Technical Hotline Hint

Release **01/05**
Issue Date: 3 March, 2005

Subject: BA Falcon/ SX Territory Auxiliary Audio input

Models: BA Falcon/BA Fairlane/SX Territory

*The below is a view of the vehicle side connector.

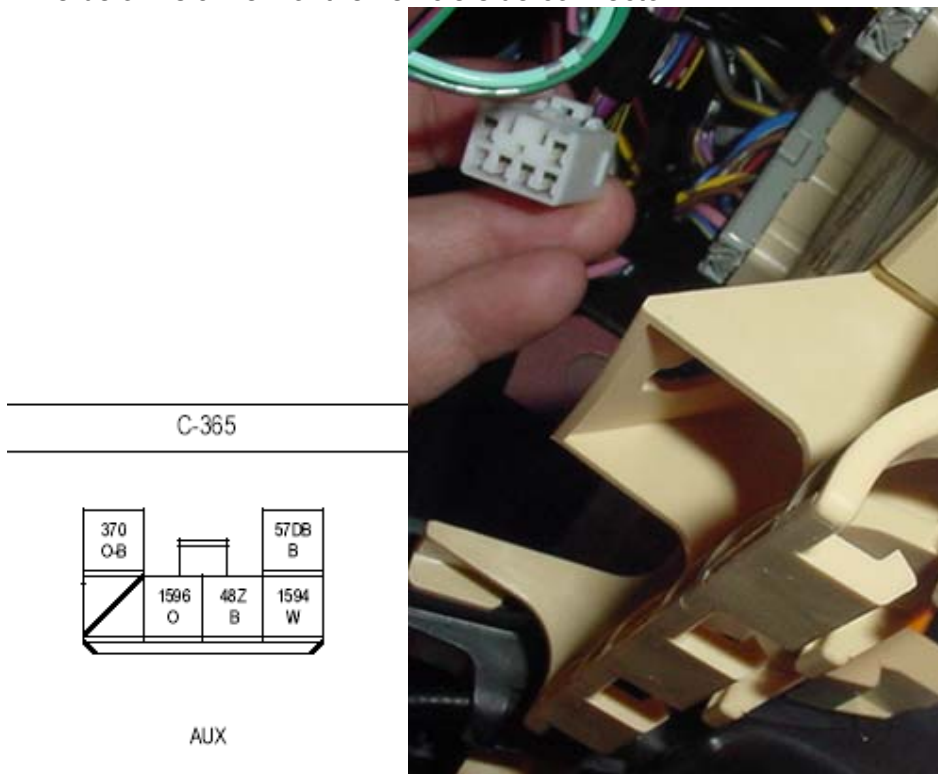
- 1) Locate the C365 connector (around fuse panel area) to find the circuits as per the image below.
- 2) Locate the auxiliary loom side of the C365 connector **NOT THE VEHICLE LOOM SIDE.**
- 3) Connect the 2 grounds by splicing the wiring together in the **auxiliary loom plug** which connects to the vehicle wiring. Circuit 57 connects to circuit 48 in connector C-365.
- 4) Check the system for correct operation and reduction in interference/noise.

Note: Circuits 370 and 57 are already connected so when the splicing is done there will be 3 circuits connected 370, 57 and 48.
